**Consultation Response from KC, Conservation & Design****2024/90758 and 2024/90759 - White Syke Farm, Marsden Lane, Marsden, Huddersfield, HD7 6AF****Renovation of outbuilding and erection of glazed lean-to on the south east elevation of the outbuilding to form domestic workshop for uses incidental to the enjoyment of the dwellinghouse (Listed Building)****Listed Building Consent for renovation of outbuilding and erection of glazed lean-to on the south east elevation of the outbuilding to form domestic workshop for uses incidental to the enjoyment of the dwellinghouse****Date Responded: 30.04.2024****Responding Officer: S Pickles****Responding Ref:**

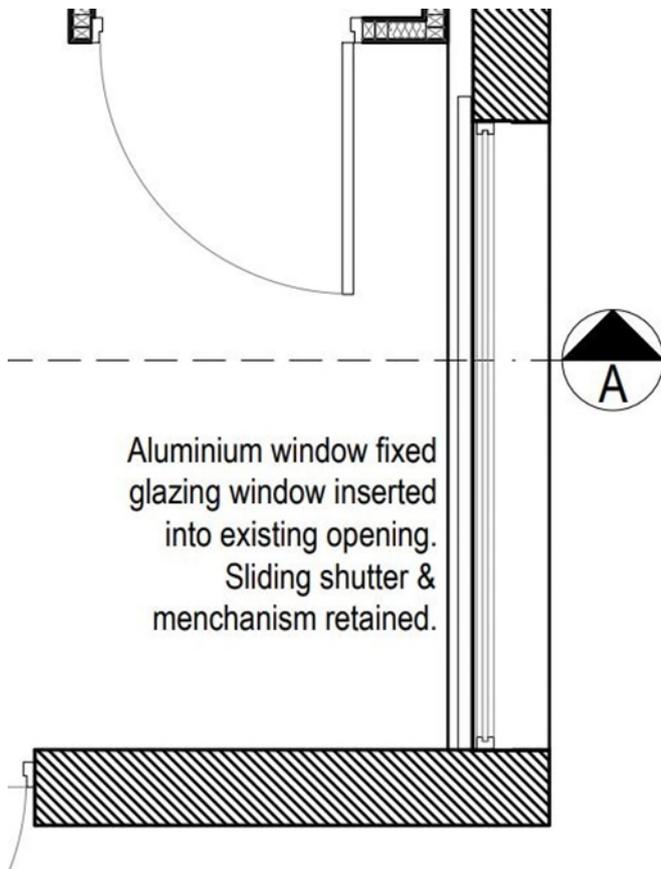
The existing sliding door to the northern elevation is shown as being retained, which we are supportive of as this will retain the character of the building, however, the plans show a glazed screen fitted to the outside of the door, which is indicated as being aluminium framed. We appreciate the reason behind

doing this, however as stated we do not support the use of aluminium frames, as this would appear overly thick and create a negative detail and this is illustrated by the elevation plans.

We consider a glazed screen could be acceptable, however, we would need the frame to be reduced, so that it appears as if this is frameless, and the screen needs to be set further back into the reveal so that the depth is retained as much as possible. Sketch plan below for reference.
